ADDENDUM NUMBER ONE

- IFB 24-912-13: INTERIOR/ EXTERIOR REPAIRS FOR UPTOWN, DOWNTOWN SCATTERED SITES AND FLORIDA HOUSING COMMUNITY
- IFB 24-912-14: INTERIOR/ EXTERIOR REPAIRS FOR WESTBANK SCATTERED SITES AND FISCHER I AND III HOUSING COMMUNITY

ADDENDUM NUMBER TWO

ADDENDUM NUMBER THREE

2 2025, 2029 & 2033 Wagner St.: Second Floor Plan A2.56 Scale: 1/8" = 1'-0"

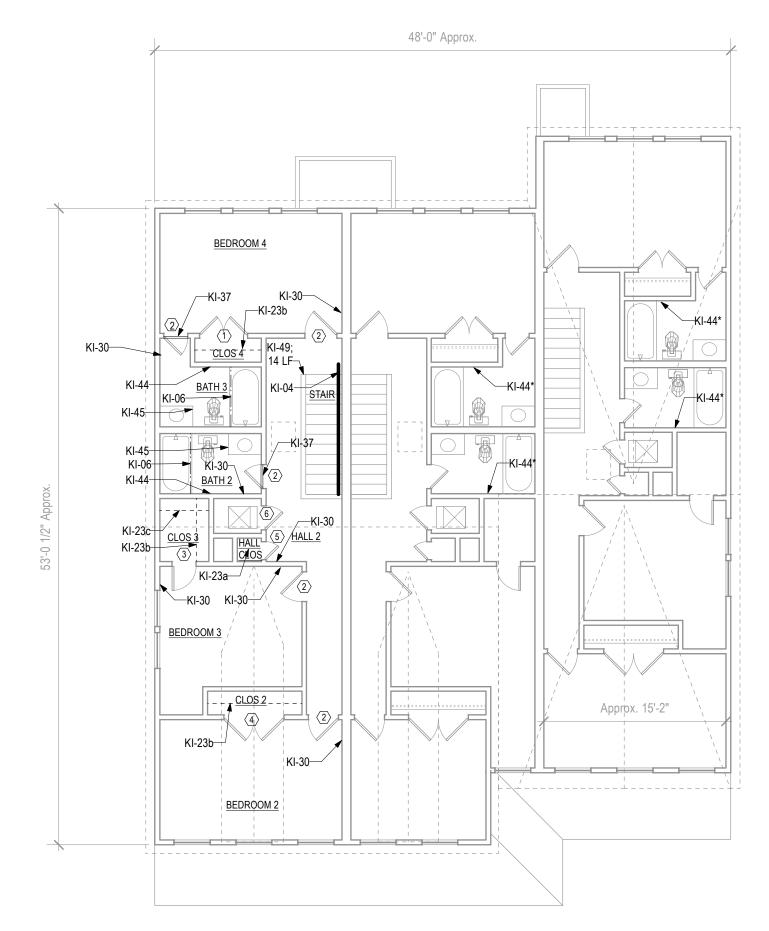
Prior to any work at 2029 and 2033 Wagner St., communicate with the Architect regarding possible HVAC work to be funded by the Cash Allowance. See Specification Section 01021.
